Technical Memorandum

SUBJECT: Review of High Timber Resources, L.P. Simsboro Aquifer Evaluation Report

DATE: July 3, 2023

Figure 1. Proposed High Timber Resources, L.P. Well Location Map

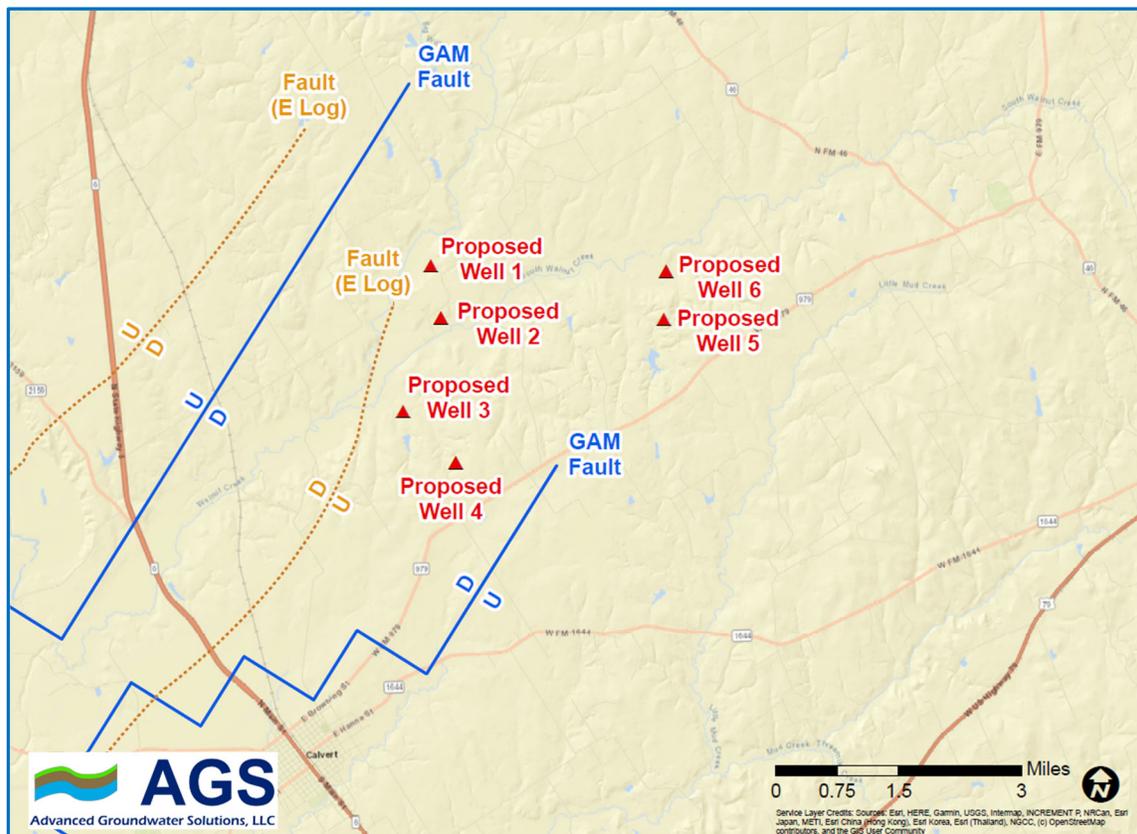
As shown on Figure 1, proposed High Timber Wells 1 through 4 are located in a down dropped area of the Simsboro Aquifer that is between two GAM estimated faults. Ground Water Consultants and AGS have mapped the Simsboro Aquifer using available electric log data in the vicinity of this geologic feature, which is known as a graben. The estimated extent of the faulting and graben mapped by GWC and AGS is shown on Figure 1 as a dashed line. Based on the electric log data reviewed, it is possible that proposed High Timber Wells 1 through 4 are not located in this geologic feature.

Figure 2. AGS This Analytical Simulated Drawdown After Proposed High Timber Pumping of 11,870 ac-ft/yr for 1-Year (TGI Hydraulic Properties)

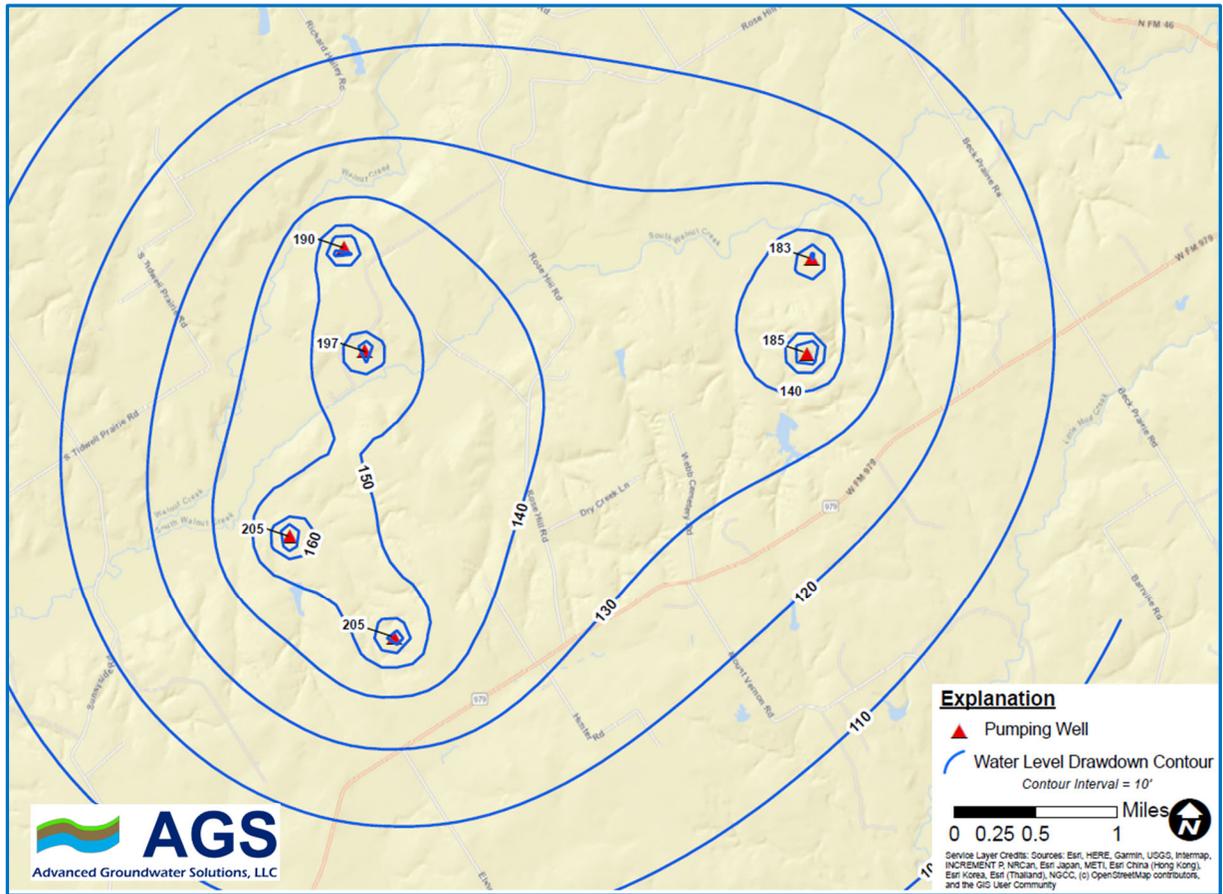
There is an increased density of contours near the proposed High Timber wells using the AGS approach and we think these are more appropriate estimates of “near well” drawdown. However, there are many factors that will determine the actual drawdown near the well during pumping, and therefore, these differences are assumed to be minor for the purposes of the AER. Figures 2 and 3 below show the estimated AGS analytical modeling drawdown contours that result from pumping 11,870 ac-ft/yr for 1-year and 10-years, respectively.

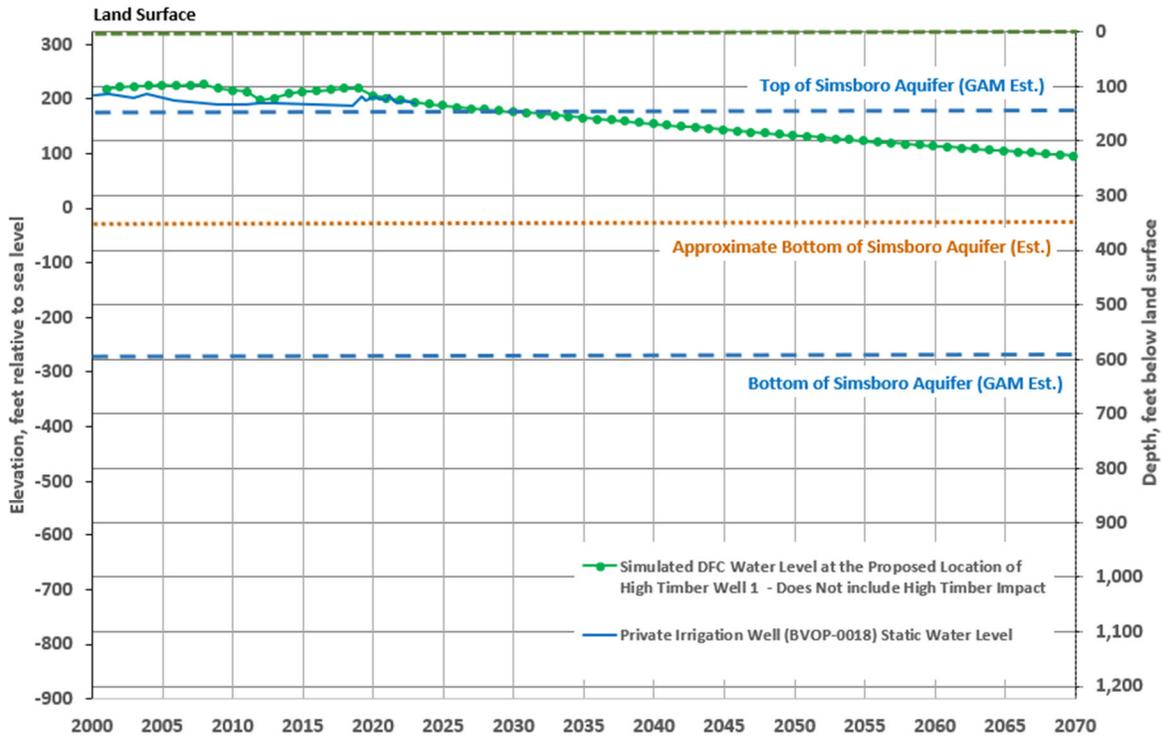
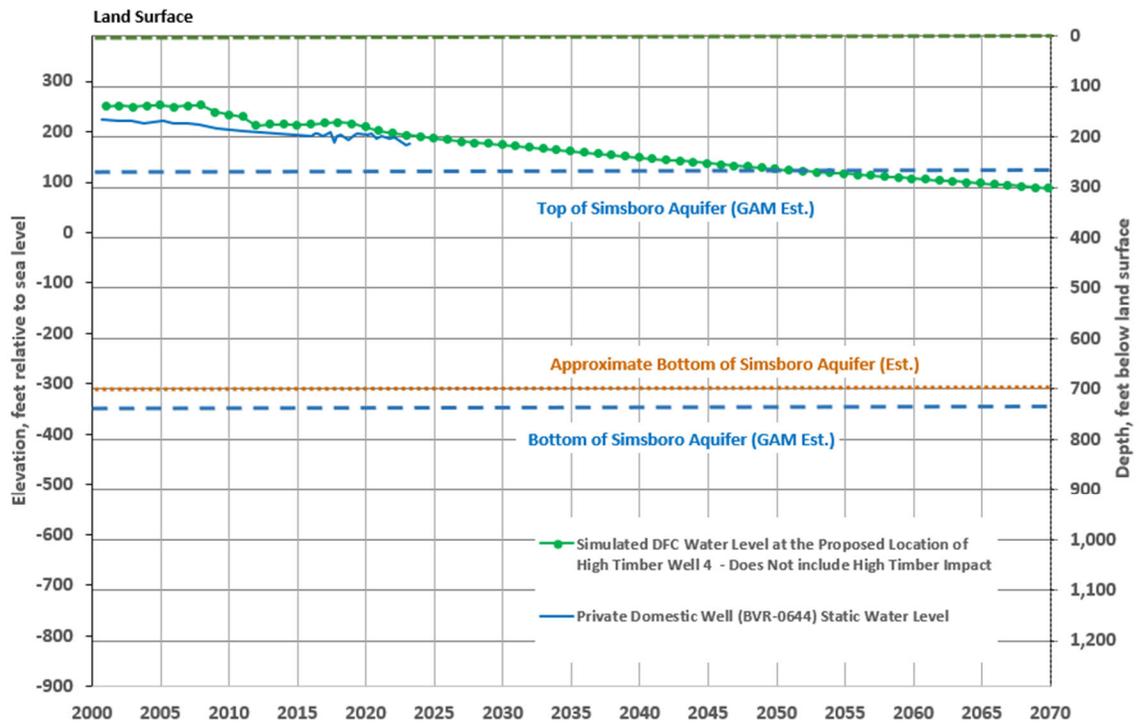
Figures 4 and 7, attached to this memorandum, show the estimated base of the Simsboro Aquifer based on the review of available local geophysical logs by AGS. The GAM estimated tops and bottoms of the Simsboro Aquifer are shown Figures 4 - 9. There are limited geophysical logs available in this area. A geophysical log shows the approximate base of the Simsboro Aquifer at a shallower depth than the GAM near proposed High Timber Well 1. A geophysical log near proposed High Timber Well 4 shows the base of the Simsboro at a depth that is similar to that shown in the GAM.
